Alarm Splitter Module Modification for -48V DC Power

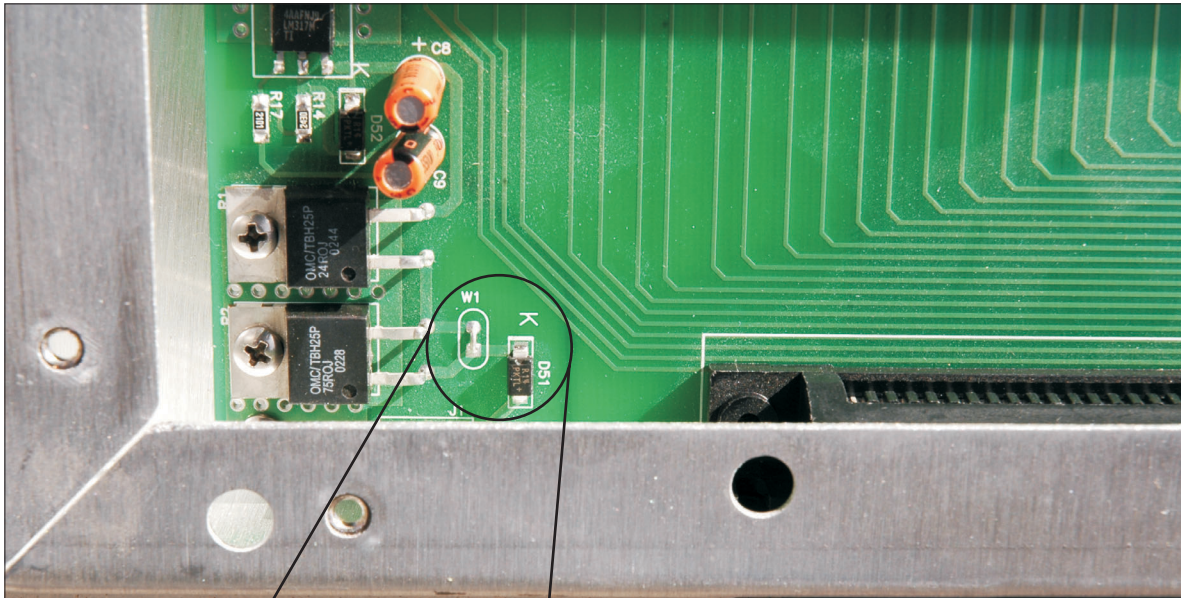
Note:
To use 48 volt power supplied to Alarm Splitter Module (Part No. 9800-4451), remove module cover and cut section out of W1 Jumper on board, as shown.
